TECHNICAL NOTE

LAND AT BURDELL ROAD, YAPTON, WEST SUSSEX RESIDENTIAL DEVELOPMENT

Client: Driftstone Homes Ltd
Reference: 6145

1.1.1 This Technical Note (TN) has been prepared by Bright Plan on behalf of Driftstone Homes Ltd address highway consultation comments raised by West Sussex County Council (WSCC) regarding the planning application F/5/21/PL for residential development on land at Burdell Road, Yapton, West Sussex.

Figure 2.1: Summary Speed Survey Data

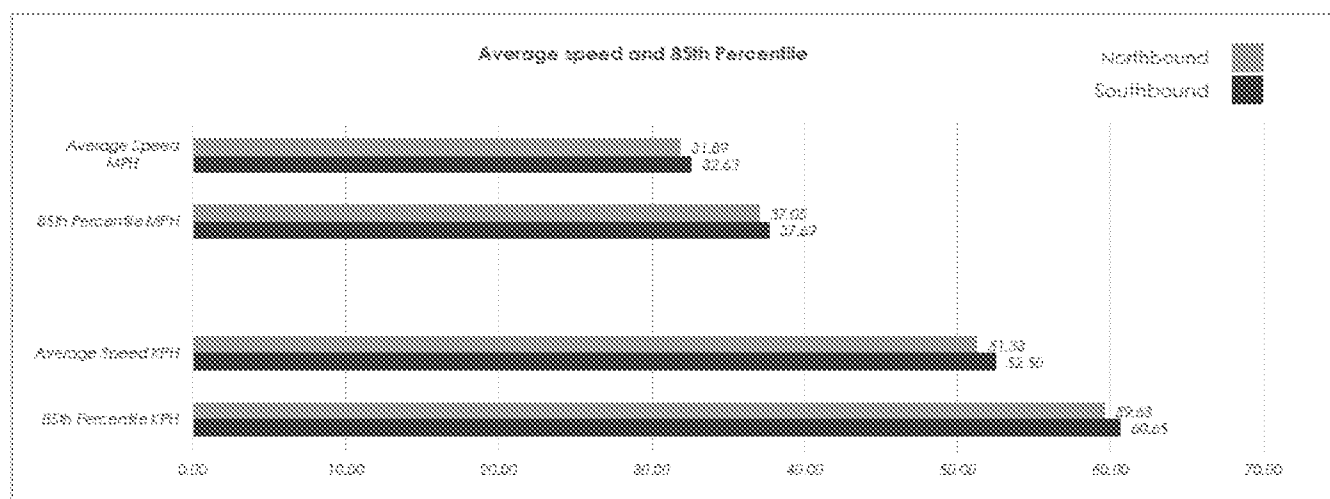
"ATC surveys taken during lockdown periods are acceptable for use in calculating 85th percentile speeds and concurrent visibility splay requirements but should not be used for traffic volume counts. The TS has taken a different approach where splays concurrent to the speed limit of 30mph and to a maximum design speed of 60kph (37.3mph) have been demonstrated. As speeds could be varying and above 37.3mph a 7-day speed survey is required to ascertain the up to date 85th percentile speeds in either direction, in vicinity of the access, along with amended vehicle visibility and pedestrian forward visibility splays in accordance with these recorded speeds."

- 2.2.1 An ATC speed Survey was undertaken between the 11th and 17th of July 2021 to establish design speeds on Burndell Road. The ATC data has been filtered in accordance DMRB CA 185 requirements. A summary of the speed data is provided in **Figure 2.1**.

- 2.2.2 The southbound design speed narrowly exceeds 60kph, a threshold at which DMRB CD 109 visibility requirements need to be considered. DMRB CD 109 identifies relaxations to the 'desirable minimum' stopping sight distance are permitted on Band B 60kph urban trunk roads. The low proportion of HGV's (<1%) on Burndell Road further supports relaxation from the desirable minimum as detailed in MfS 2 Section 10.1.

Drawing Status	FINAL		
Client	Driftstone Homes		
Project	Burdell Road, Yapton		
Drawing Title	Access Overview and Visibility Splays		
Scale	1:250	Date	July 21
Drawn By	SMO	Checked By	ALB
Drawing No.	2020-6145-001		Rev.
		I

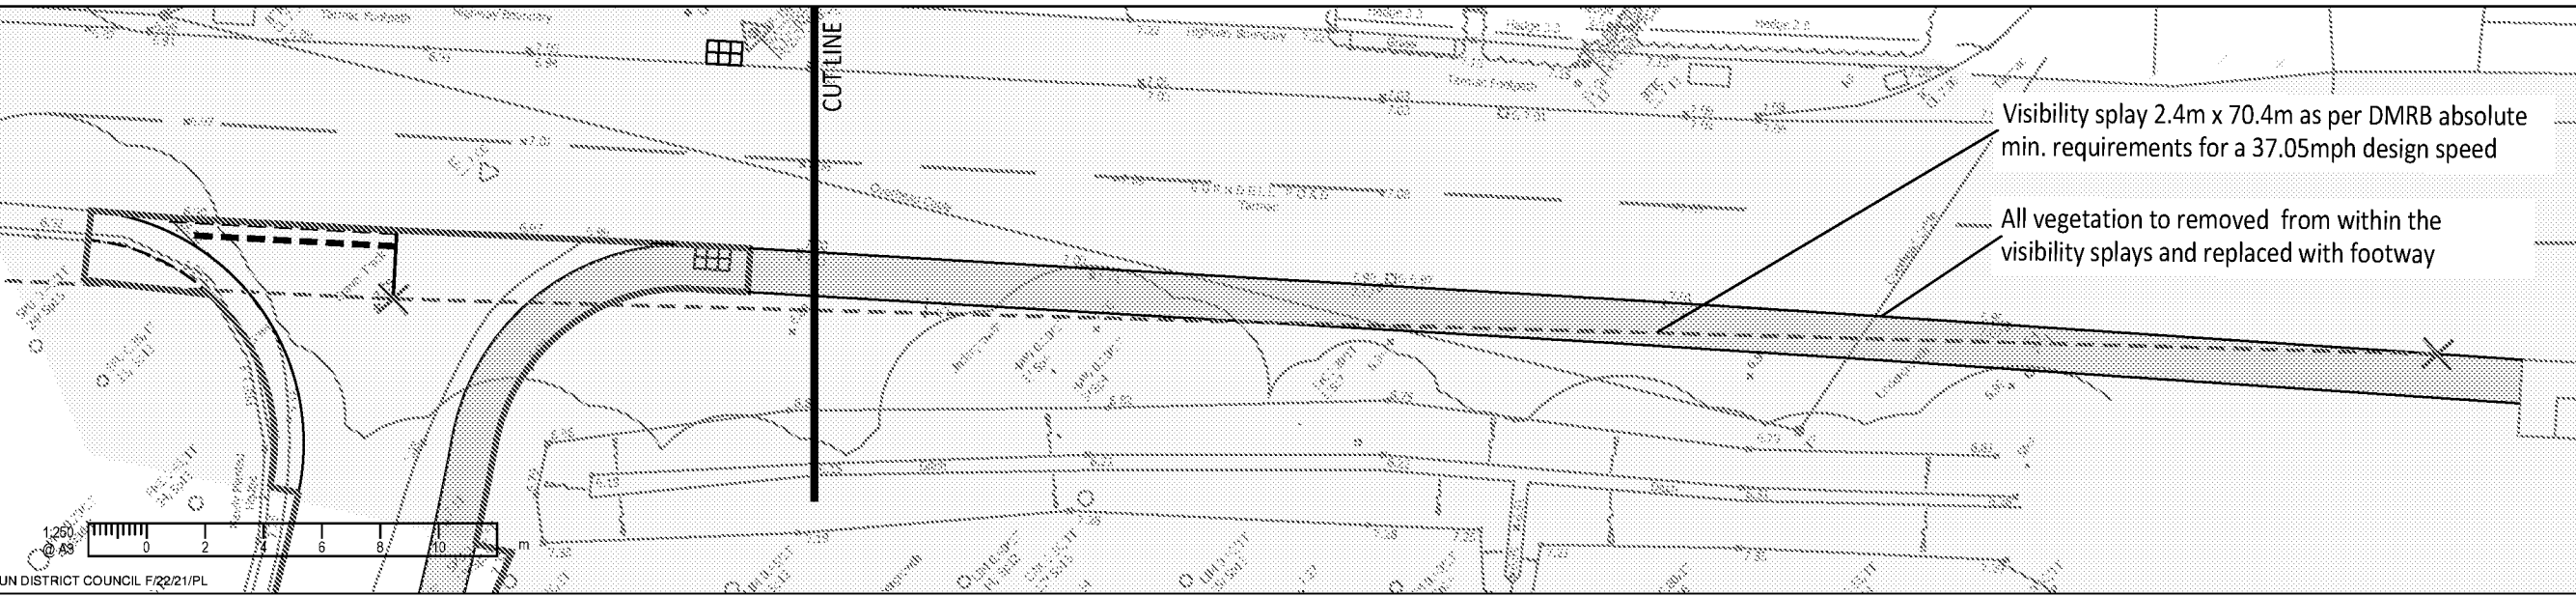
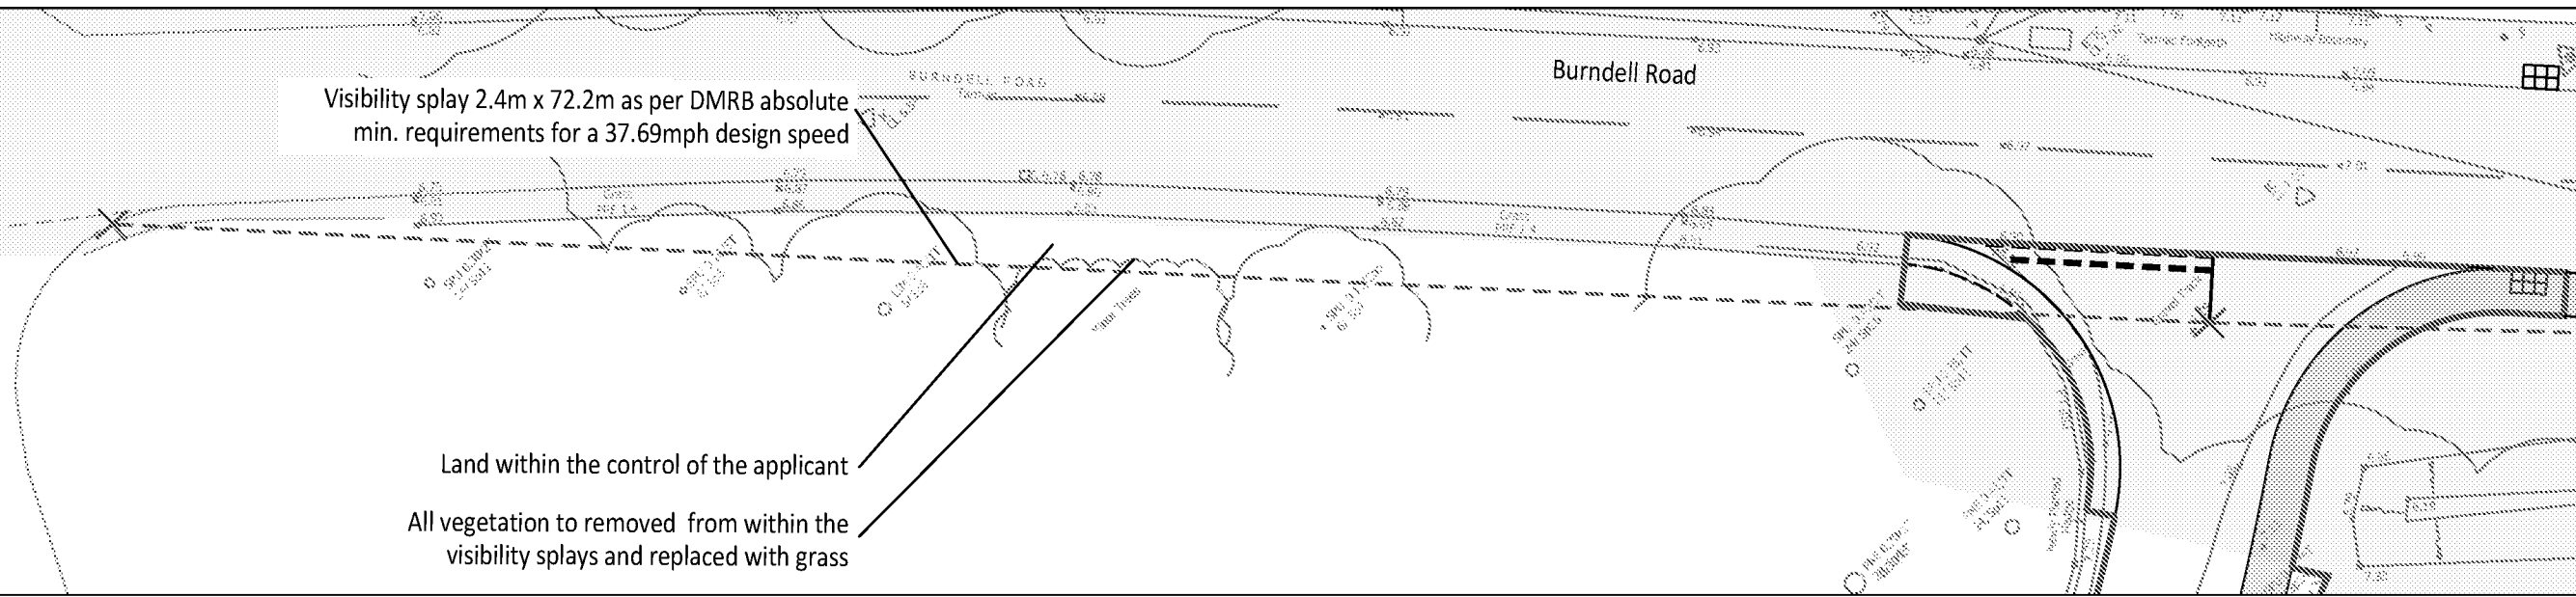
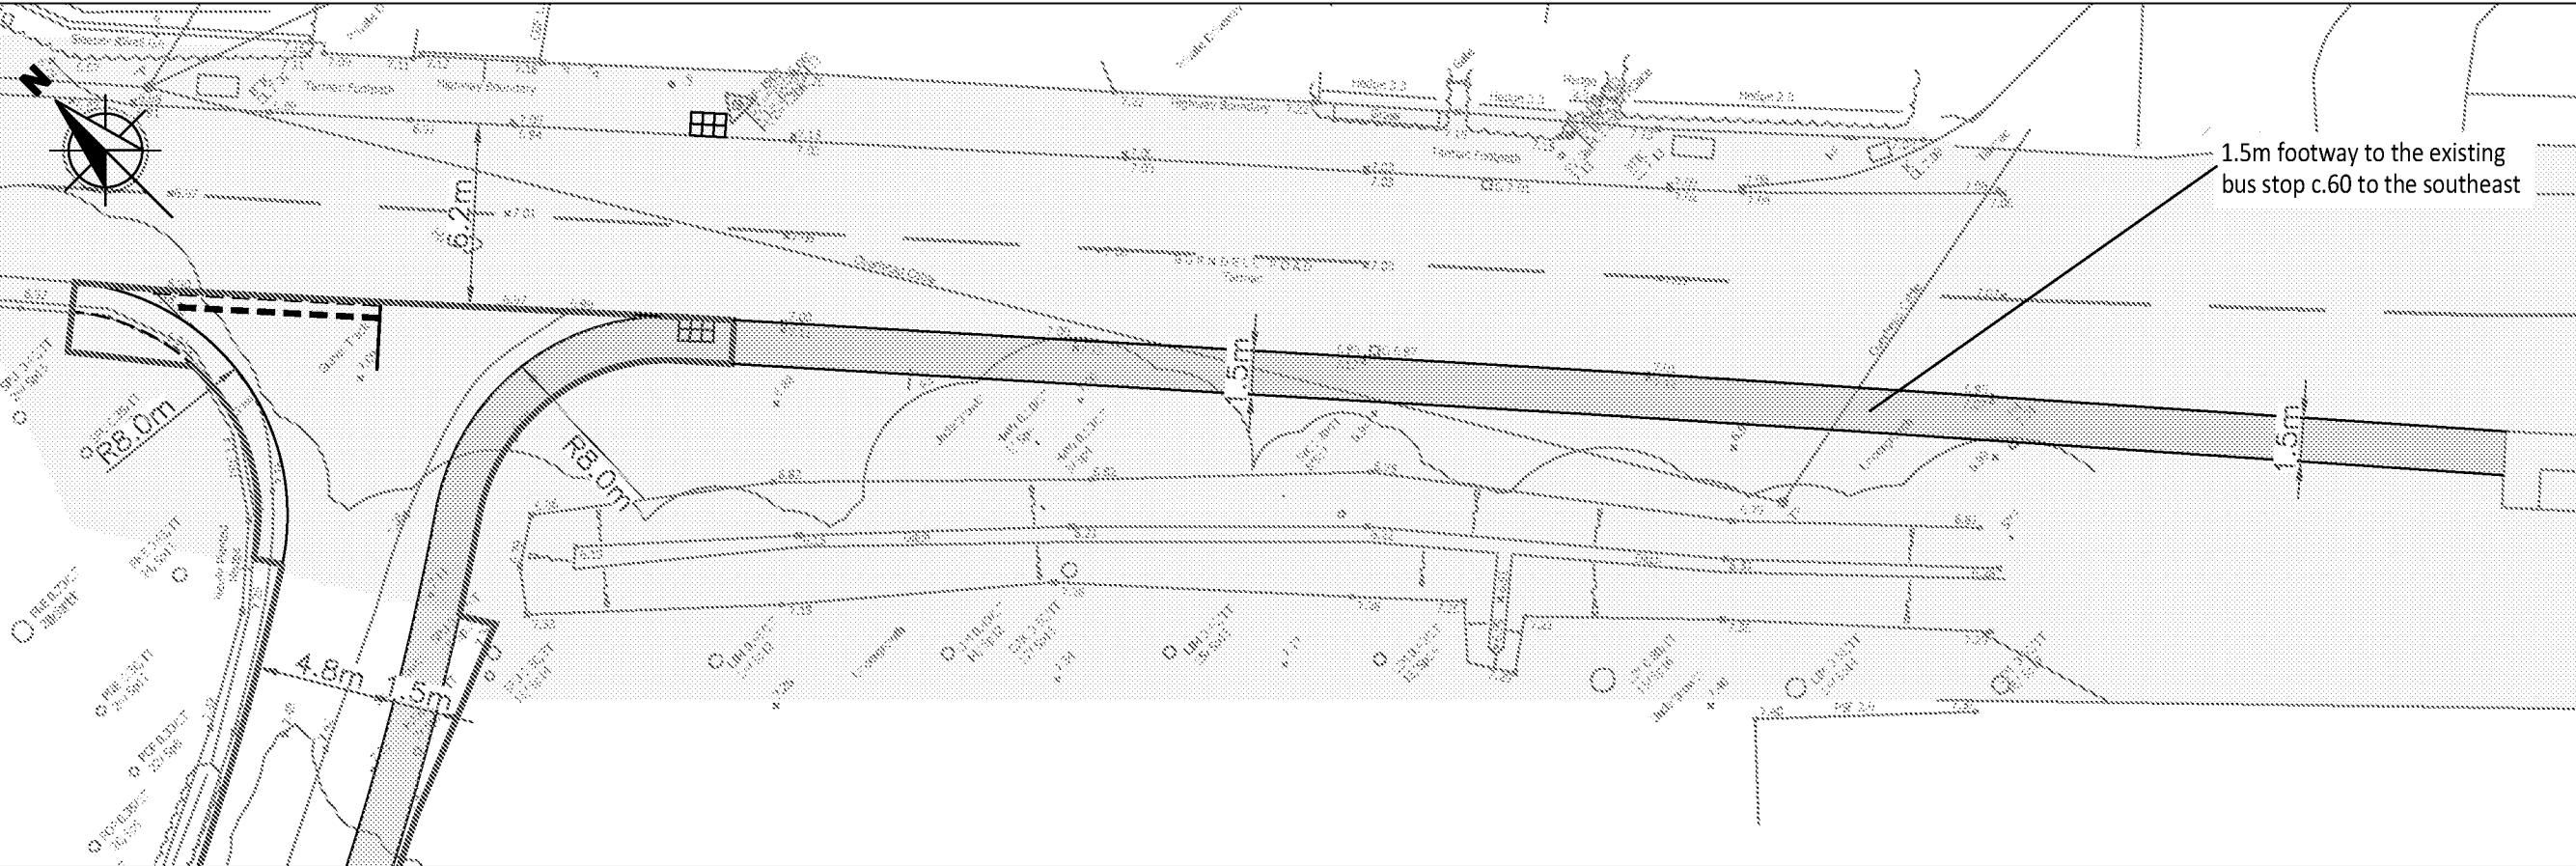
Locations: A – The access junction onto Burndell Road (Dwg. 2020-6145-001 Rev. H)

Summary: Risk of side impact collisions due to the visibility from the access road being obstructed by vegetation.

Although the post and rail fence will require removal, and the existing vegetation will be cut back, to obtain the visibility splay in both directions from the access road, the amount of overgrown vegetation present (brambles, nettles, low tree branches etc – see photos 1 and 2) will need constant maintenance to ensure that the visibility splays are not obstructed, especially to the south-eastern side of the access junction where approaching traffic will be closest to the give way lines as vehicles exit the development. Any obstruction to visibility is likely to increase the risk of side impact collisions at the access junction.

- 2.2.3 The secondary direction visibility splay has therefore been shown in accordance with DMRB 'absolute minimum' requirements equating to a stopping sight distance of 72.0m. The primary direction visibility splay has also been provided in accordance with DMRB absolute minimum requirements for consistency (although speeds on this approach direction fall below the DMRB 60kph threshold) equating to a stopping sight distance of 70.0m. The revised primary and secondary visibility splays are demonstrated in **Drawing 2020-6145-001**.

All vegetation, including low branches from adjacent trees, should be removed completely from within the proposed visibility splays, and replaced with either grass or a footway (to the south-east – see recommendation to problem 2.2).

Problem no.	Problem Accepted (yes/no)	Recommended Measure Accepted (yes/no)	Design Organisation Response	Over Seeing Organisation Response	Agreed RSA Action
2.1	Yes	Yes	All vegetation will be removed from within the visibility envelope. Vegetation to be replaced with grass to the north west and a 1.5m wide footway to the south east.		
2.2	Yes	Yes	The footway has been extended c.60m to the southeast to provide access to the existing bus stop.
